**3127 HMC ARCHITECTS
1570 The Alameda, Suite 330
San Jose, California 95126**

Chabot Las Positas Community College District
Chabot College - Buildings 800, 900, & 1000 Modernization
Hesperian Boulevard
Hayward, CA
HMC #3342002

ADDENDUM NO. 2

Item No. AD-2.3: Reference Revised Drawings E0.0, E4.0, E4.2, & E6.

Scale NTS	Project No. 3342002-100
Ref. sheet No. E0.0	Date 11/19/07 Drawing No. ESK-1

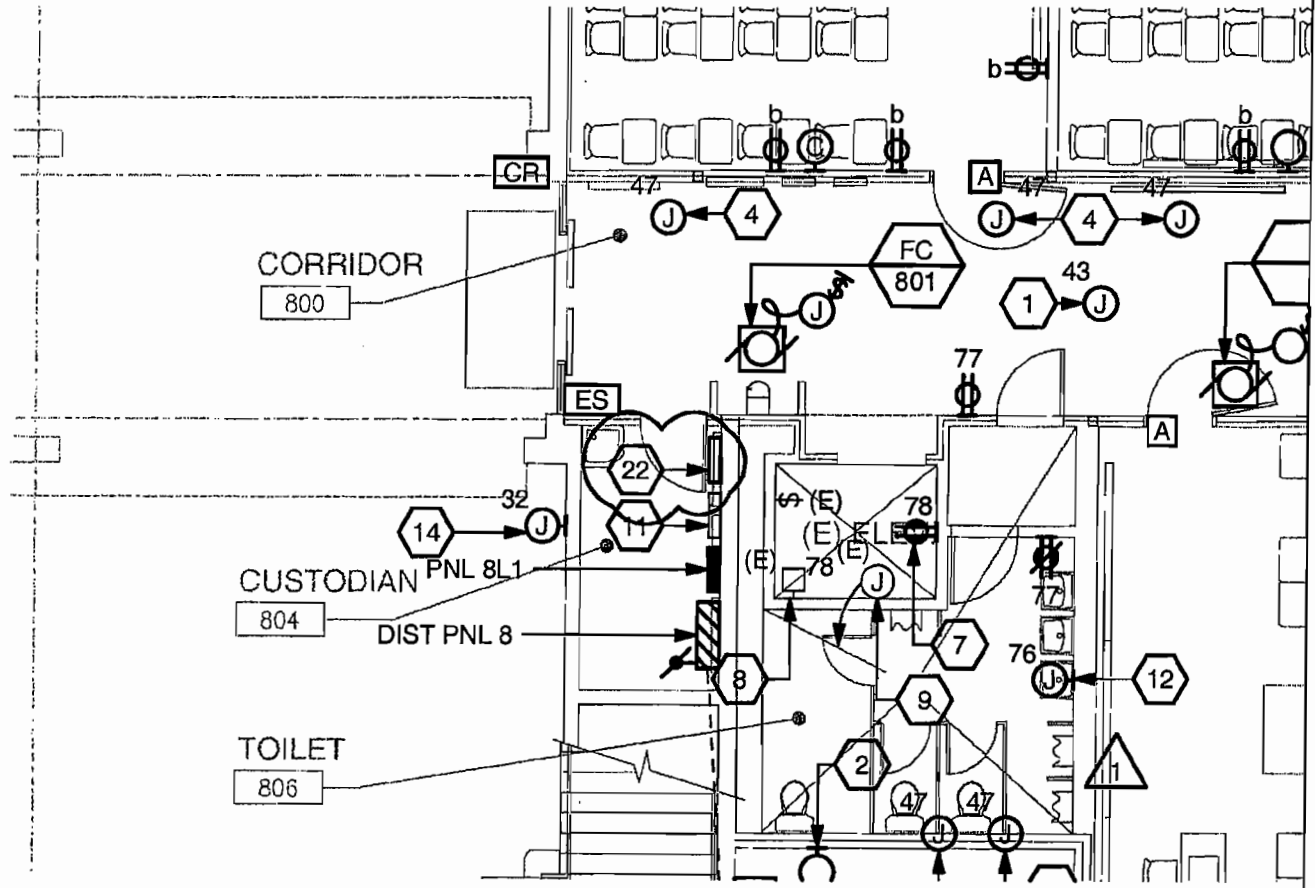
- A. Sketches ESK-1 to ESK-4 are hereby issued modifying the Electrical Drawings noted above. These sketches address the project security system to be provided.

KEYPAD - PROVIDE RECESSED 4" X 4" GANG BOX AT 48" AFF. PROVIDE 1"C TO ACCESSIBLE CEILING SPACE. TAG AND LABEL GANG BOX. REFER TO 3/E6.0 FOR MORE INFORMATION.

OCCUPANCY SENSOR - PROVIDE RECESSED SIGNLE GANG BOX AT 8'-0" AFF. PROVIDE 1"C TO ACCESSIBLE CEILING SPACE. TAG AND LABEL GANG BOX. REFER TO 3/E6.0 FOR MORE INFORMATION.

DOOR CONTACT - PROVIDE RECESSED 4" X 4" GANG BOX. LOCATE ABOVE DOOR. PROVIDE 1"C TO ACCESSIBLE CEILING SPACE. TAG AND LABEL GANG BOX. REFER TO 3/E6.0 FOR MORE INFORMATION.

CARD READER - PROVIDE RECESSED 4" x 4" GANG BOX AT 48" AFF. PROVIDE 1"C TO ACCESSIBLE CEILIN GSPACE. TAG AND LABEL GANG BOX. REFER TO 3/E6.0 FOR MORE INFORMATION.

ELECTRIC DOOR STRIKE - COORDINATE WITH DOOR HARDWARE. REFER TO 3/E6.0 FOR MORE INFORMATION.

BUILDING 800 1st FLOOR ELECTRICAL FLOOR PLAN

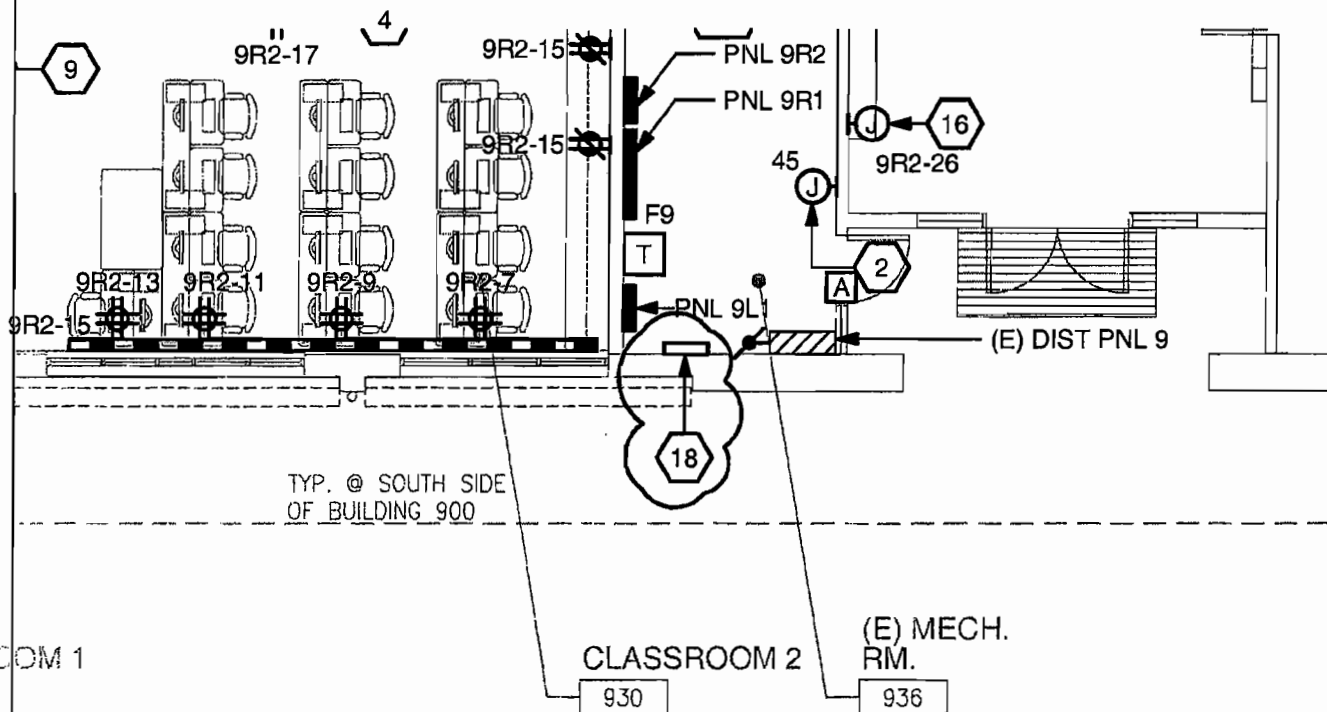
LOCATED UNDER WINDOWS, DRILL FURRING STRIPS AS REQUIRED TO MOUNT DEVICE IN SPECIFIED LOCATION. CONDUIT SHALL BE CONCEALED WHILE RUNNING HORIZONTAL IN THE WALL. FILE NO. 1-01 DSA# 01-108817

- 21 PROVIDE WIREMOLD 880 SERIES FLOOR BOX WITH GPCI DUPLEX OUTLET. SAWCUT (E) FLOOR FOR INSTALLATION OF NEW CONDUIT. REPAIR FLOOR TO MATCH ADJACENT SURFACE.
- 22 SECURITY CONTROL PANEL. CONNECT TO PNL "8R1" CKT 80. PROVIDE DATA DROP ADJACENT TO PANEL.

3 SECURITY RISER DIAGRAM
 NOT TO SCALE

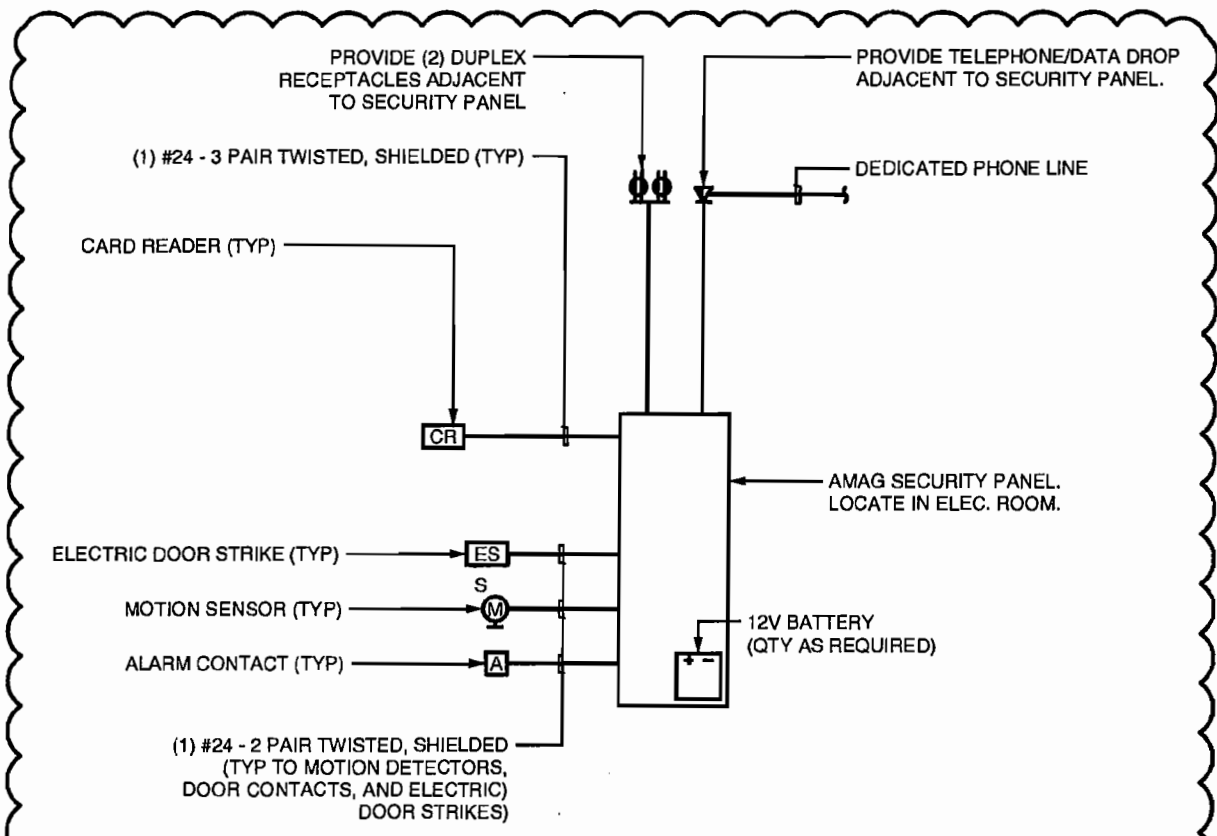
- 16 PROVIDE CIRCUIT FOR LIGHTING WITHIN DISPLAY CASE. PROVIDE WALL SWITCH ADJACENT TO DISPLAY CASE TO CONTROL DISPLAY CASE LIGHTING.
- 17 CIRCUIT DEVICES OIN THIS ROOM TO PNL "9R2". COORDINATE EXACT LOCATIONS OF DUPLEX RECEPTACLES AT EACH ENLARGING STATION WITH OWNER PRIOR TO INSTALLATION.
- 18 SECURITY CONTROL PANEL. CONNECT TO PNL "8R1" CKT 80. PROVIDE DATA DROP ADJACENT TO PANEL.

1. QTY OF DEVICES ARE INDICATED ON DRAWINGS.
